Re: **Petition No. 1178 – Petition of Fusion Solar Center, LLC for a Declaratory Ruling that no Certificate of Environmental Compatibility and Public Need is Required for the Construction, Operation and Maintenance of a 20 MWac Solar Photovoltaic Project in Potash Road in Sprague, Connecticut**

**RESPONSES OF FUSION SOLAR CENTER, LLC  
TO CONNECTICUT SITING COUNCIL QUESTIONS**

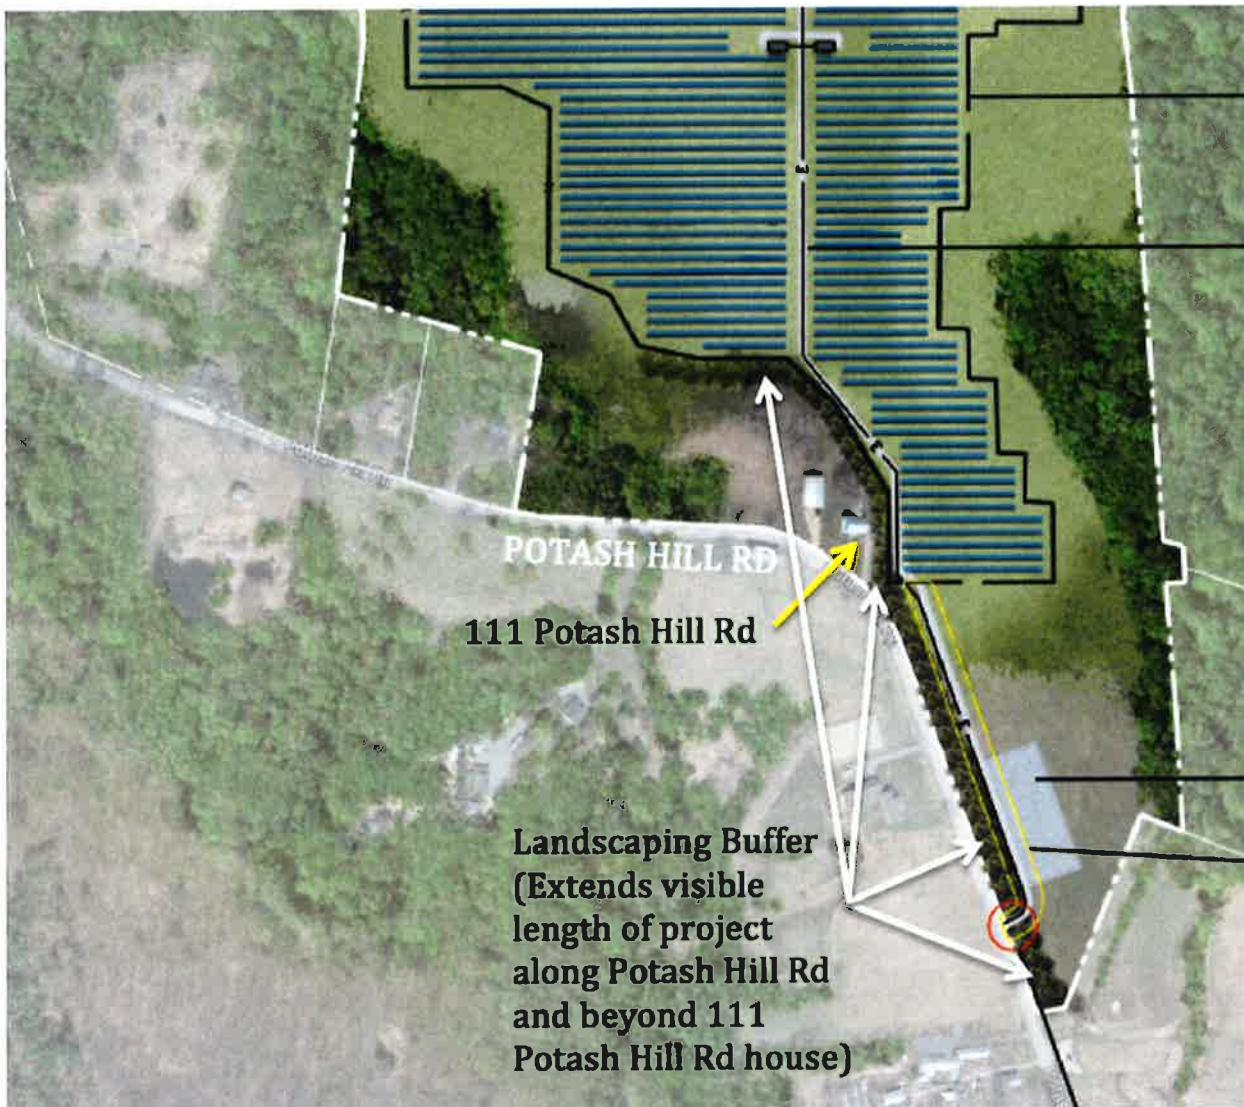
Question No. 2

Is the Petitioner amenable to planting trees along Potash Hill Rd. to reduce the visual impact to residents? Clarify which portion of the subject propert(ies) frontage along Potash Hill Rd. would have tree plantings.

Yes, the Petitioner is amenable to planting shrubs and/or trees (no taller than 8-10 feet in height at maturity) along Potash Hill Road to provide a suitable visual screen of the project area. This visual screen will be designed to establish the visual buffer while not negatively impacting the efficiency or output of the project. As noted in the site plan renderings submitted with the Petition (*See Exhibit A and Exhibit G of the Petition*), the Petitioner envisions plantings extending from the southern end of the Rainville property along Potash Hill Road and extending north and west to the residence at 111 Potash Hill Road. The Petitioner would envision extending the plantings to the west behind the residence at 111 Potash Hill Road to a point adjacent to existing tree line. The existing natural vegetative screening in the westerly portion of the project area will provide substantial natural screening to the west of 111 Potash Hill Road. The figure below highlights the planting locations, as represented in Exhibit C to the Petition.
